With the current plans to develop the property at 501 S. Greensboro Street (former Rogers-Triem property), the Roberson Place neighborhood has grave concerns about the potential connection of the southern end of Purple Leaf Place with Rand Road and the proposed South Green development.

Below are a list of questions and concerns our neighborhood has as it relates to South Green traffic impact study.

Map of Roberson Place, South Green, and connection point

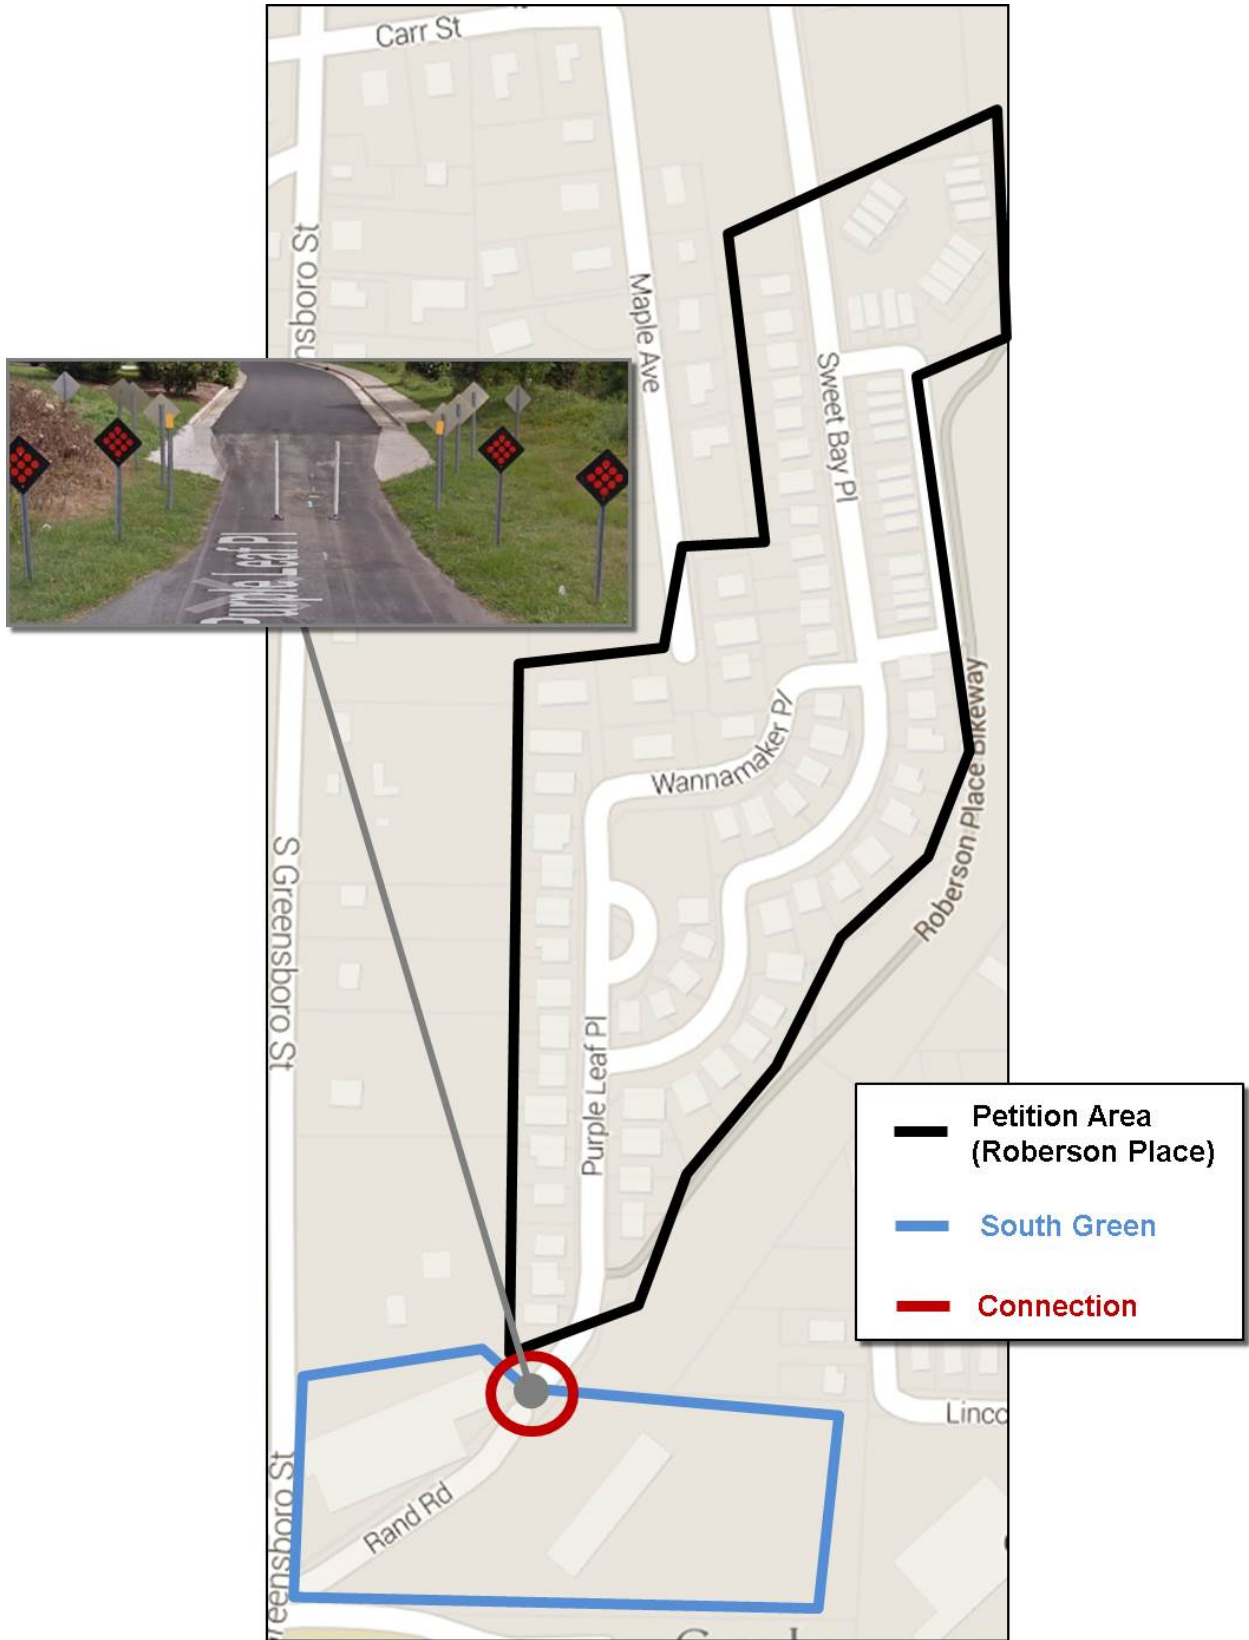
- **The connection between Purple Leaf Road and Rand Road/South Green development remain in its current condition and closed to vehicular traffic. Noting that the current condition consists of a barrier of plastic bollards (removable/temporary barriers) allowing only bike, pedestrian, and emergency vehicle access.**
- **Connection is made by sidewalk and bikeway adjacent to Purple Leaf Place between the Roberson Place Bikeway and the proposed South Green development. This connectivity is intended to provide for safe pedestrian and bike access from Roberson Place to/from South Green/Greensboro Street.**
